# Wisconsin Department of Transportation

**Proposal #24: 4992-01-71  
 C Menasha, Third St  
 Lake Winnebago Slough & Approaches  
 Loc St  
 Winnebago County**

This is Addendum No. 01, which provides for the following:

**ADDENDUM NO. 01**

Addendum No. 01  
 ID 4992-01-71  
 Revised Sheet 32  
 May 4, 2016

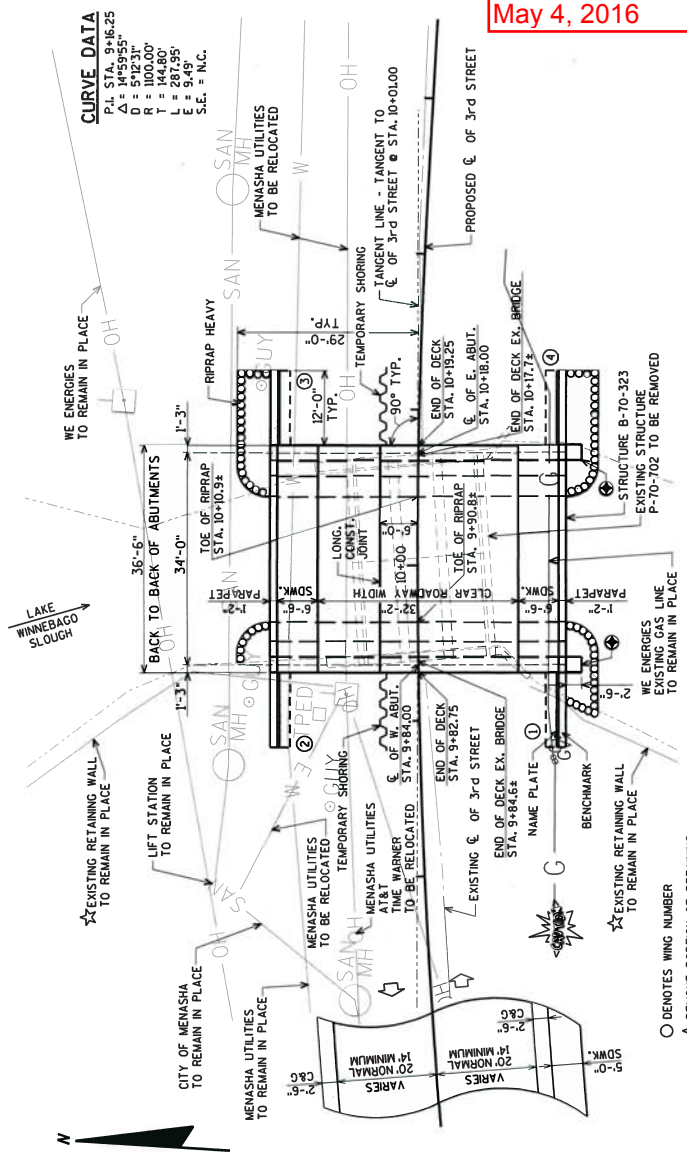
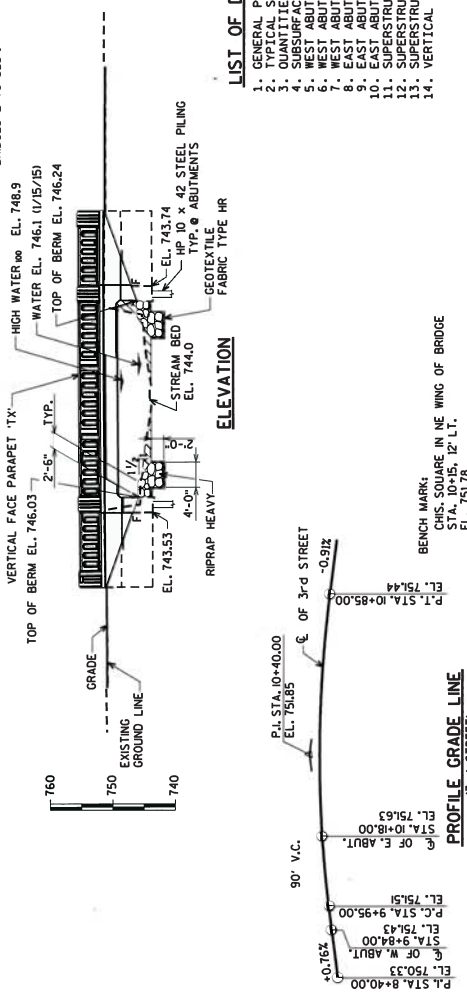
Revised Plan Sheets	
Plan Sheet	Plan Sheet Title (brief description of changes to sheet)
32	Structure B-70-323 General Plan – Update notes
34	Structure B-70-323 Quantities and Notes – Quantity Revisions
38	Structure B-70-323 West Abutment Bill of Bars - Update notes and Bill of Bars
41	Structure B-70-323 East Abutment Bill of Bars - Update notes and Bill of Bars
42	Structure B-70-323 Superstructure – Update Bill of Bars

NO.	DATE	REVISION	BY
5/16		UPDATE TX RAIL AND REMOVE PILE POINTS	AYRES

Addendum No. 01  
ID 4992-01-71  
Revised Sheet 34  
May 4, 2016

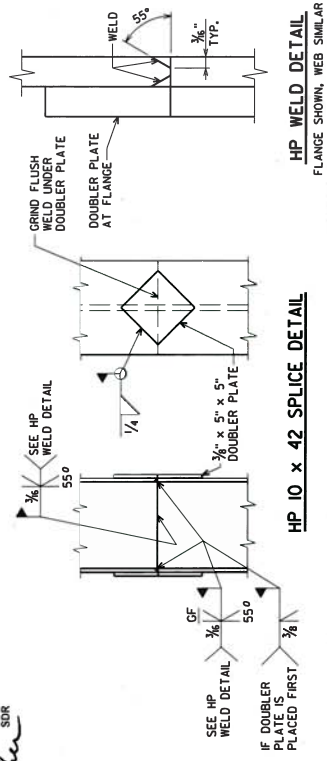
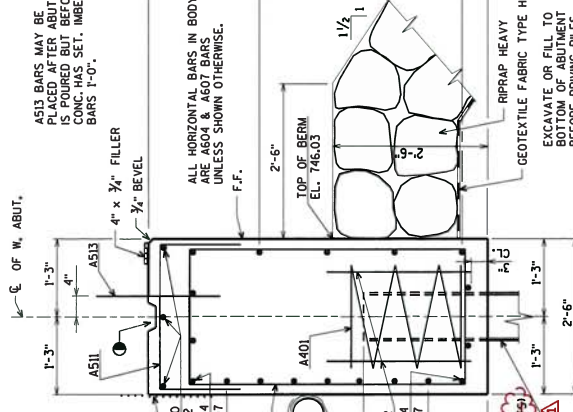
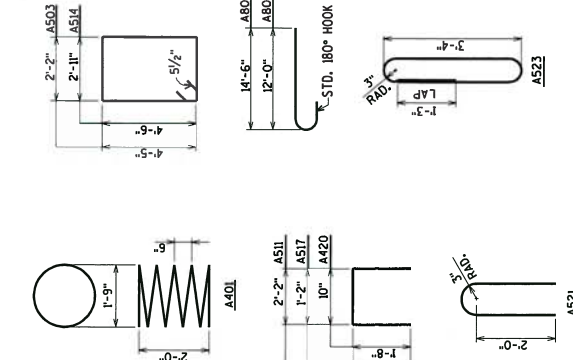
5/16	UPDATE TX RAIL AND REMOVE PILE POINTS	AYRES	BY
NO. DATE	REVISION		
STATE OF WISCONSIN DEPARTMENT OF TRANSPORTATION			
STRUCTURE B-70-323			
DRAWN BY	SCALE	PLANS	AEB
QUANTITIES AND NOTES			SHEET 3 OF 14
			34

Addendum No. 01  
ID 4992-01-71  
Revised Sheet 38  
May 4, 2016

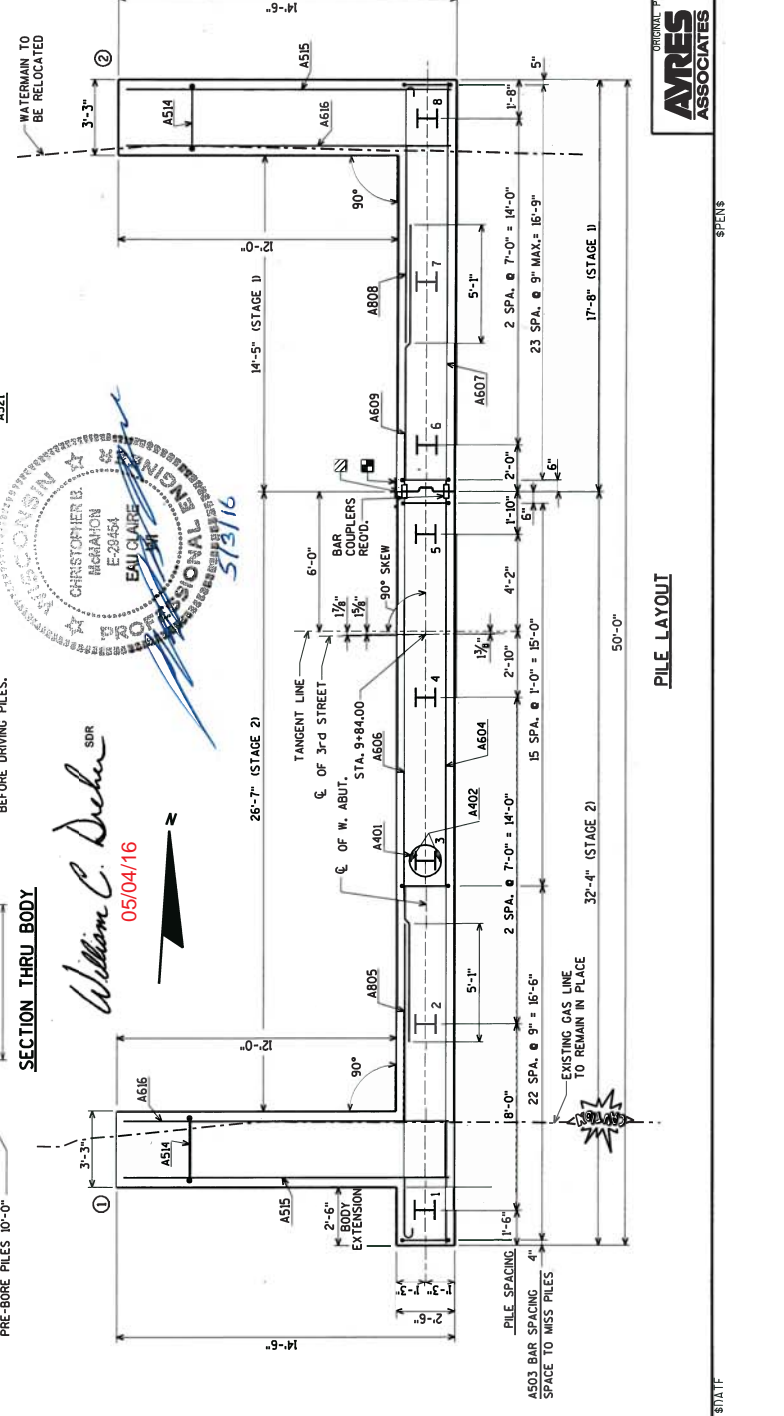
UPDATE TX, RAIL AND REMOVE PILE POINTS

Addendum No. 01  
ID 4992-01-71  
Revised Sheet 41  
May 4, 2016

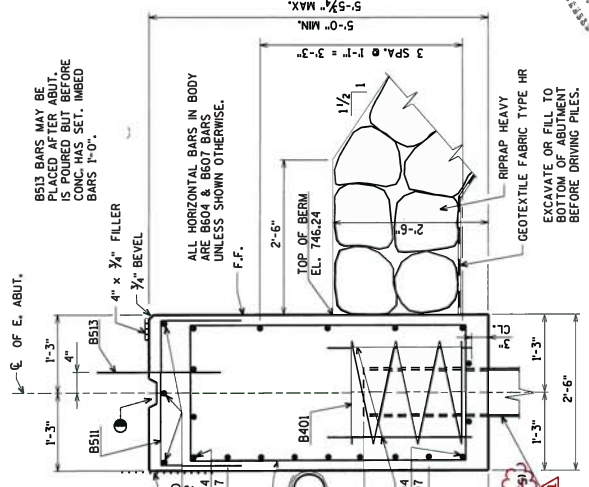
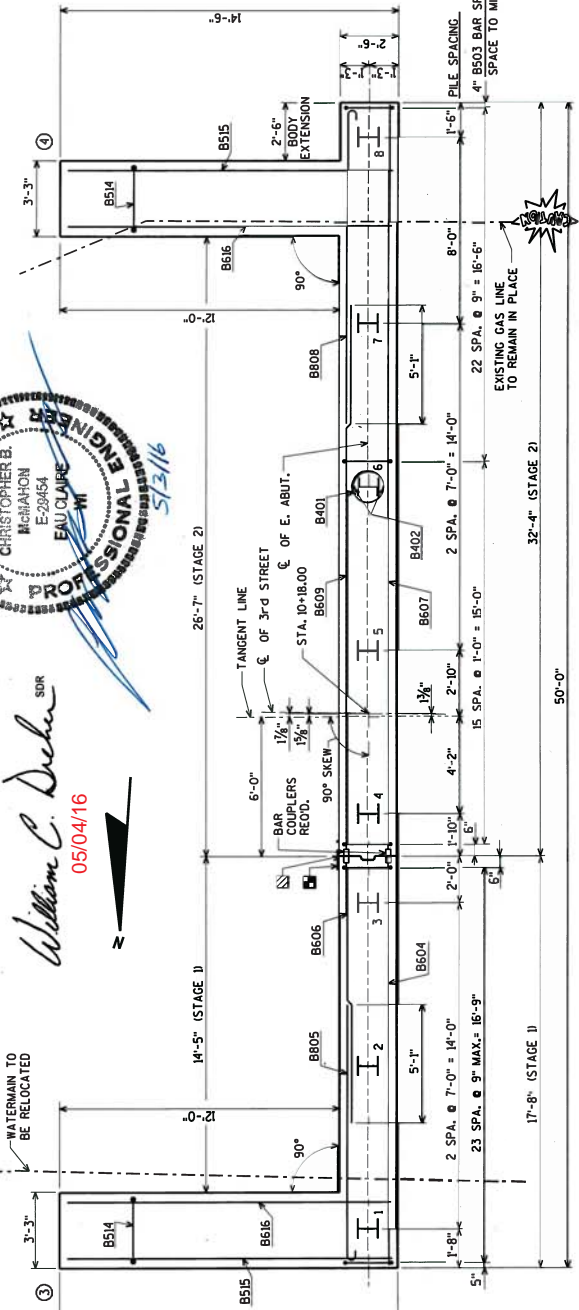
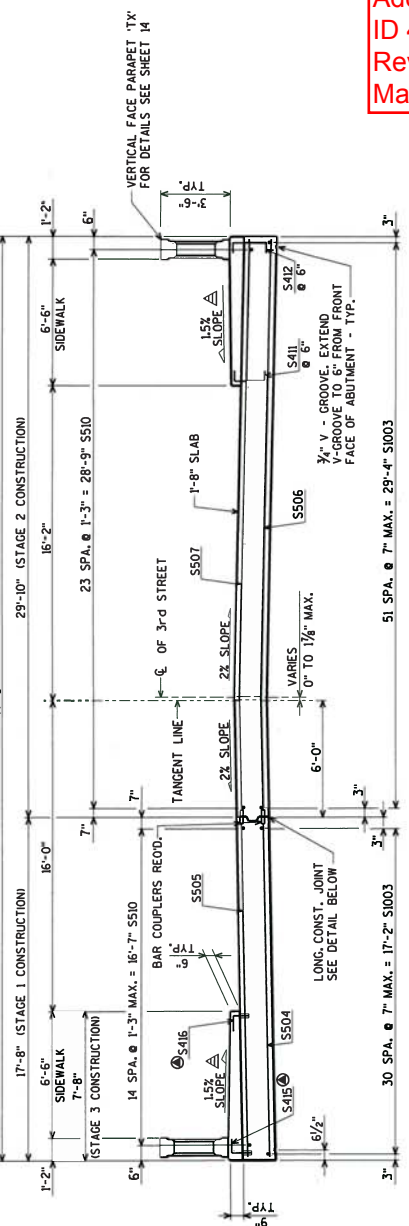
5/16 UPDATE TX RAIL AND REMOVE PILE POINTS  
NO. DATE REVISION  
STATE OF WISCONSIN  
DEPARTMENT OF TRANSPORTATION
